Urgent Field Safety Notice

Model A610 DBS Version 3.0.x

Clinician Programmer Tablet Application Displays System Error During Interrogation - Software Update

Medtronic Reference: FA1188

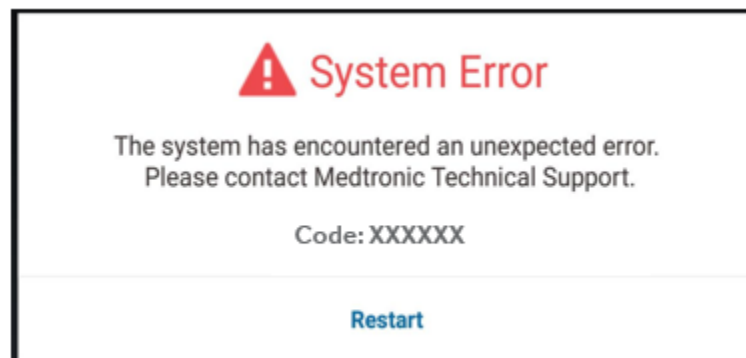
If this issue occurs, you will encounter a system error message similar to the one below:

Error codes seen with this issue include, but may not be limited to, codes 0x4b81f1a3 and 0x791ebfe0.
